# Proposal for LHC BLM Disabling Rules after LS1

*Re-location of 2<sup>nd</sup> position quadrupole BLM to the close-by dipole-dipole interconnection*

# Text Changes to the Document LHC-OP-MPS-0012

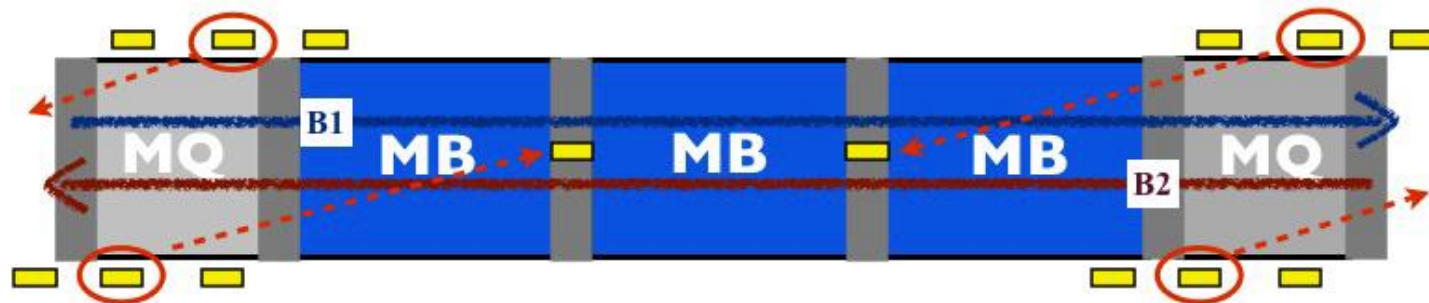
- A maximum of one IC per beam and quadrupole magnet allowed to be disabled. If one arc IC is disabled in the half cell  $n$ , the corresponding monitor of the same family in the half cells  $n-2$ ,  $n+2$  and  $n+4$  (counted in beam direction) shall remain operational.

- A maximum of one IC per beam and quadrupole magnet allowed to be disabled. If one arc IC is disabled in the half cell  $n$ , the corresponding monitor of the same family in the half cells  $n-2$ ,  $n+2$  ~~and  $n+4$  (counted in beam direction)~~ shall remain operational.
- In addition, one dipole-dipole interconnect IC per half-cell can be disabled, but only if no neighboring quadrupole monitor is disabled.
